S4.55 CHANGES

CLIENT: ANGLICARE CASTLE HILL
ADDRESS: 284 CASTLE HILL RD, CASTLE HILL NSW 2154
DRAWING: EXISTING & DEMOLITION PLAN WEST

PROJECT
201656 WESTERN ROAD

APPROVED BY: CA
CHECKED BY: TW
CLIENT: ANGLICARE CASTLE HILL
ADDRESS: 284 CASTLE HILL RD, CASTLE HILL NSW 2154
DRAWING: ELEVATIONS - BUILDING 9A

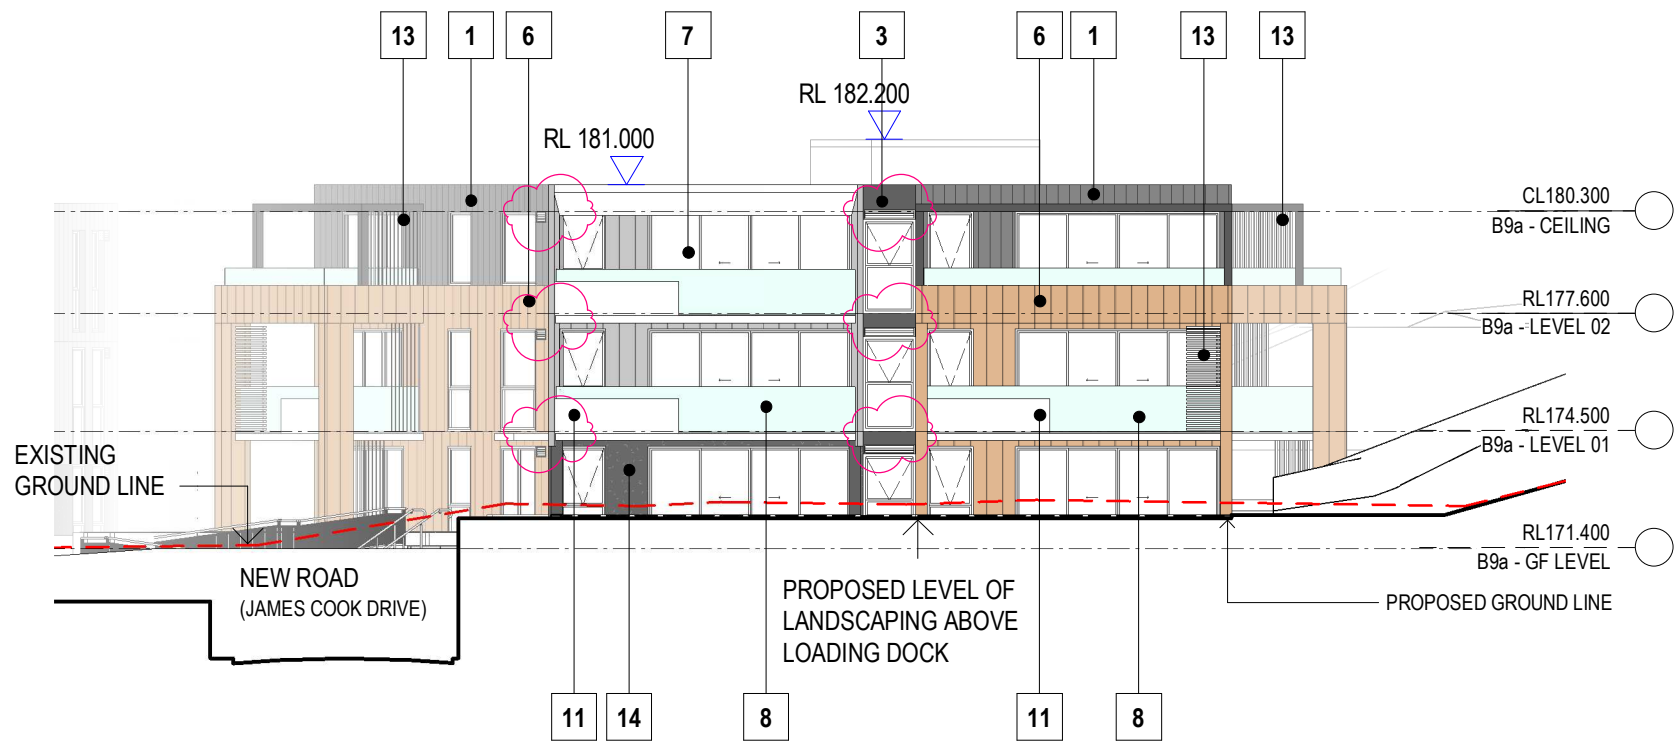
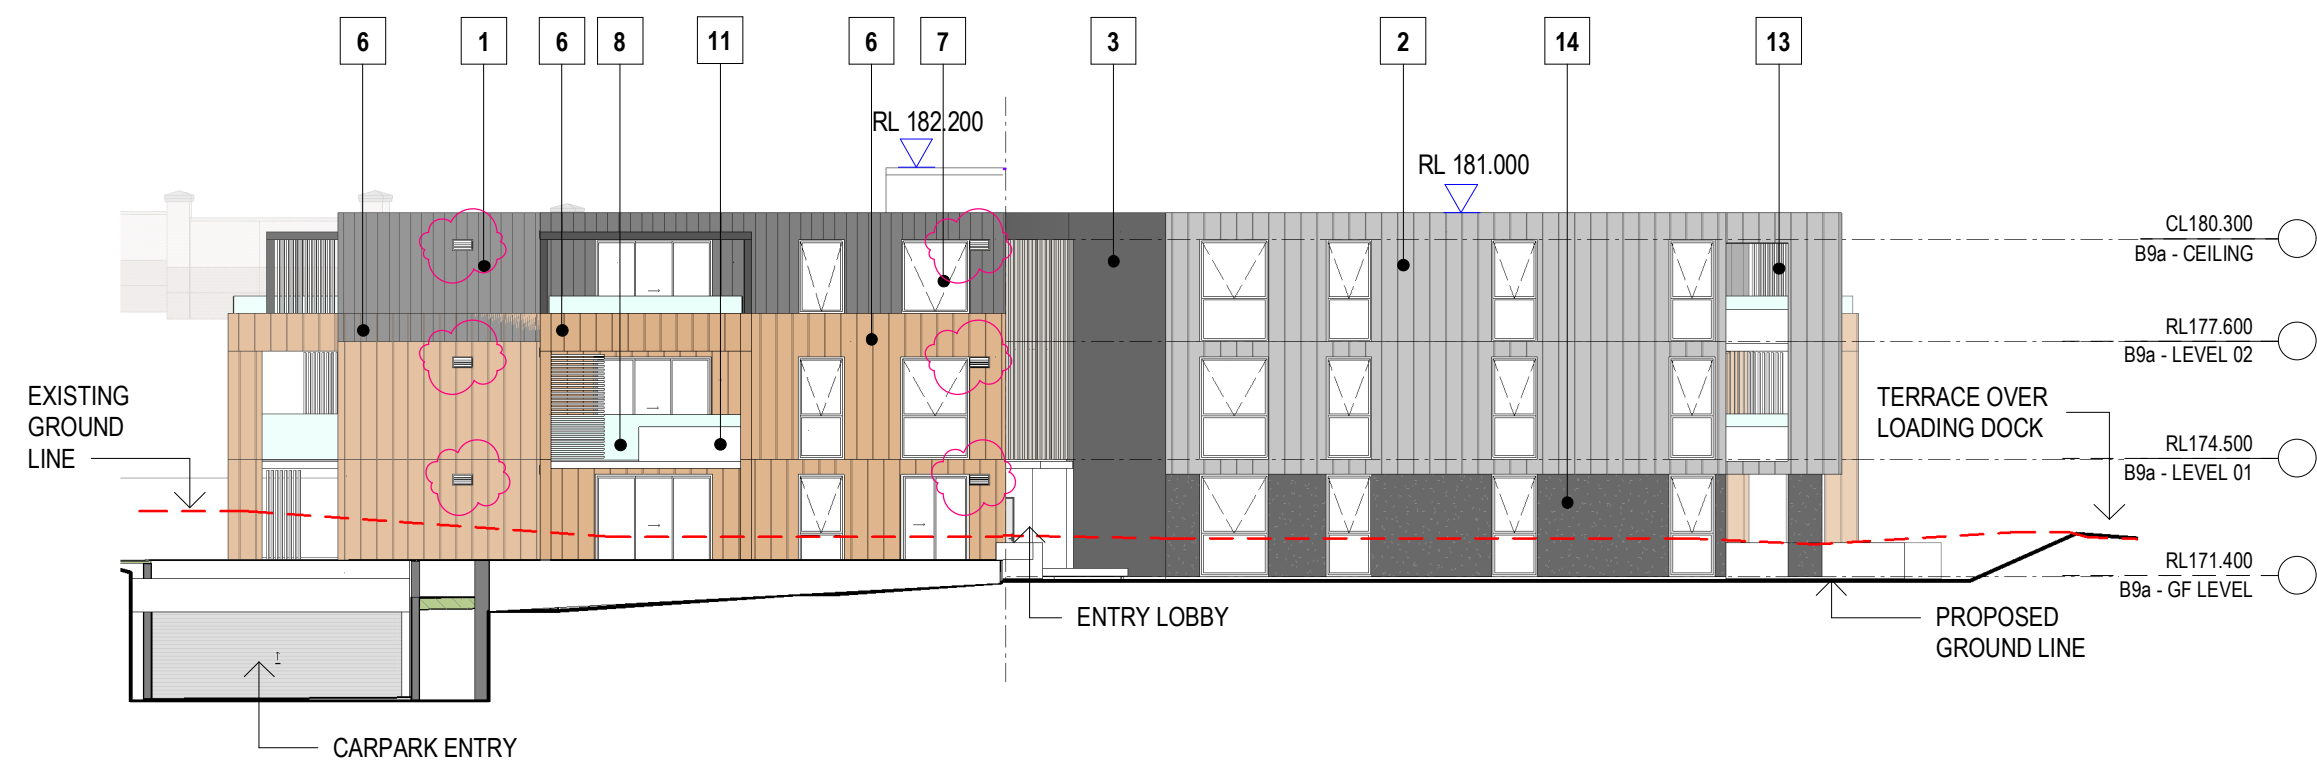
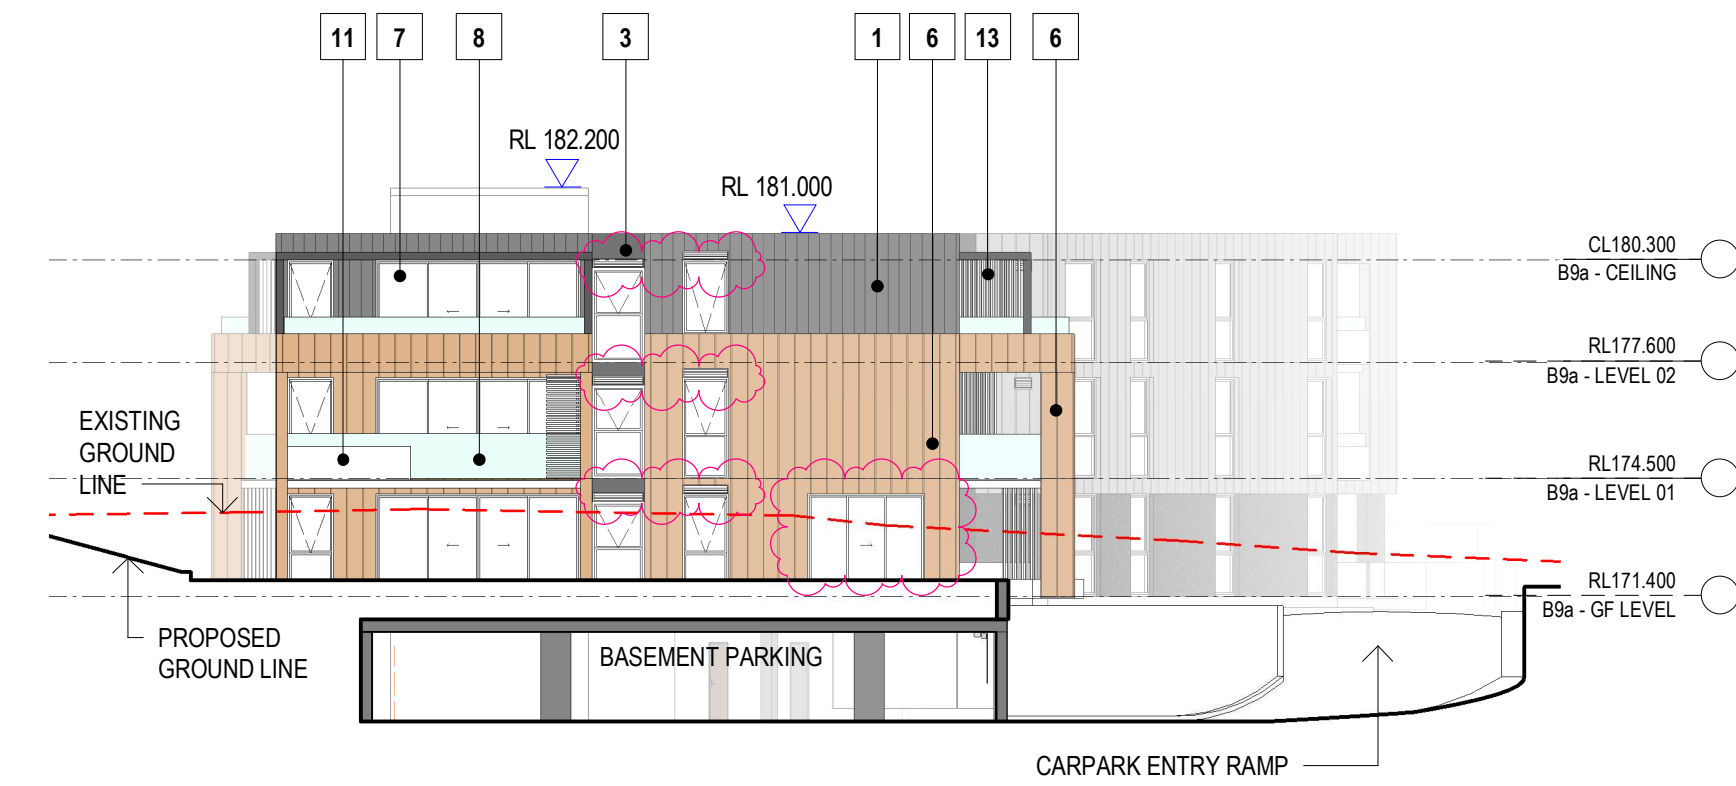
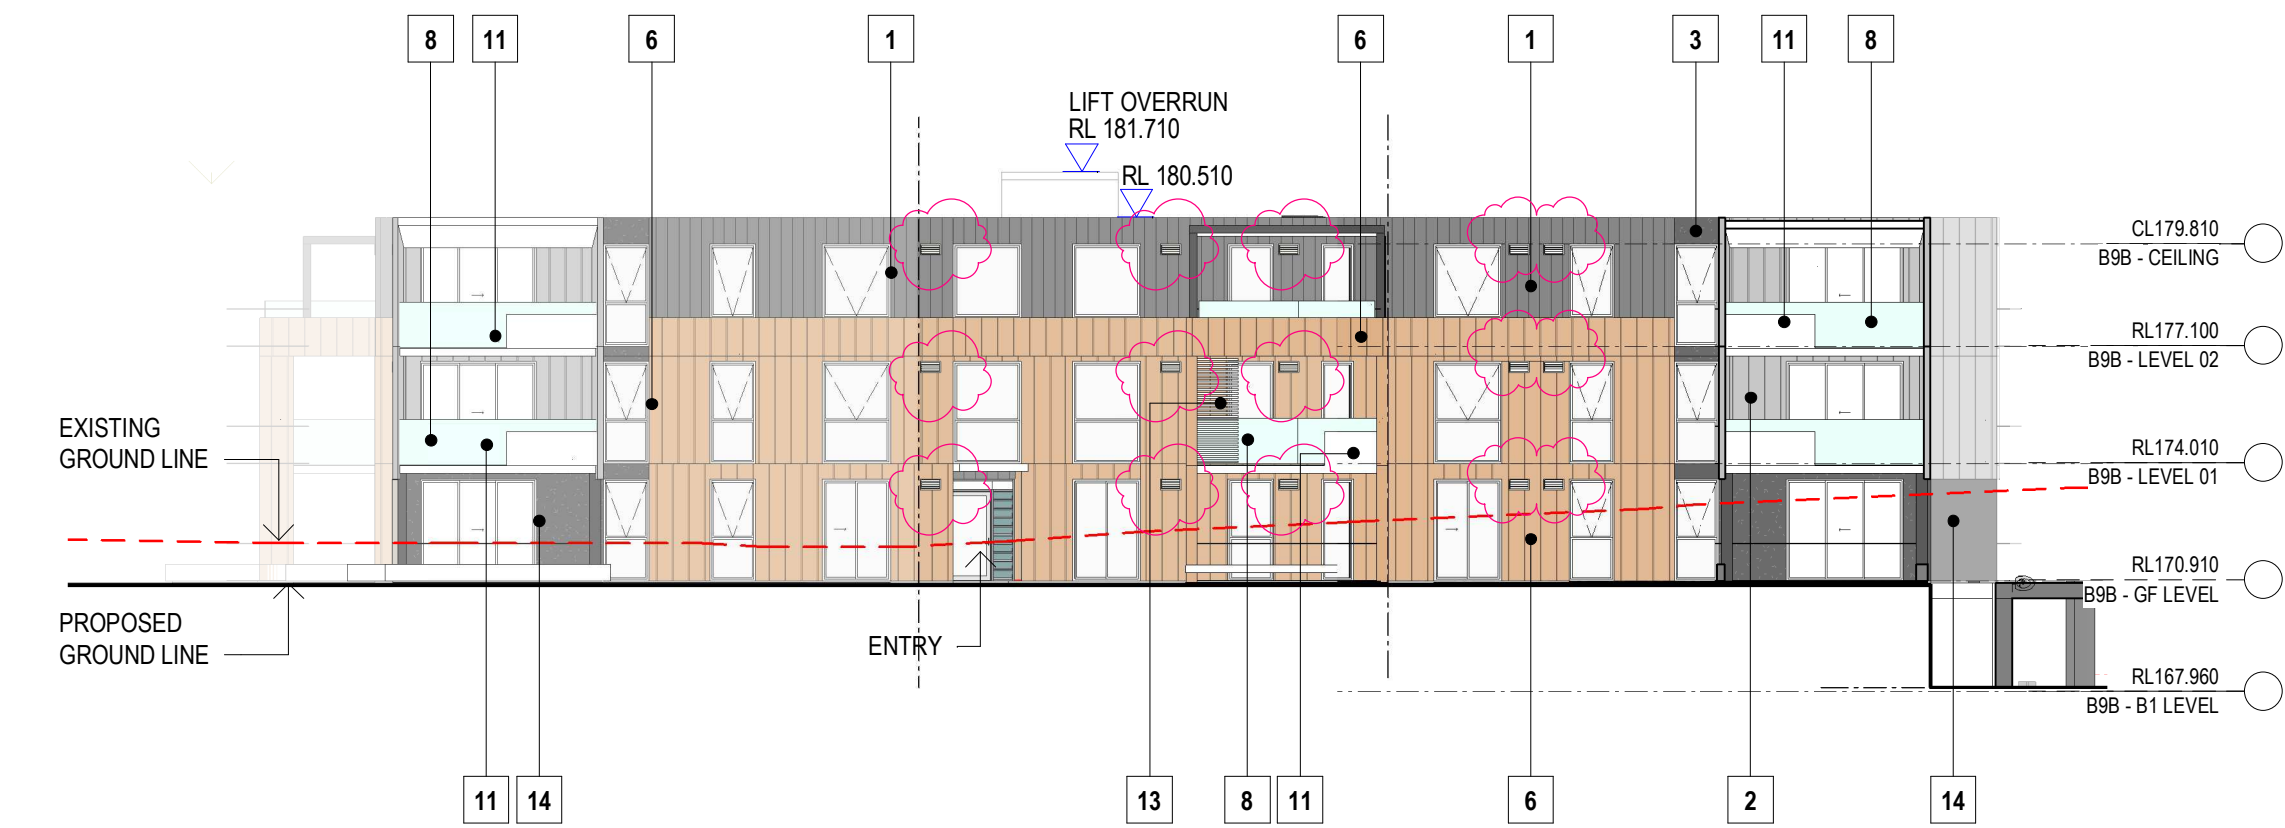
- MECHANICAL LOUVRES ADDED
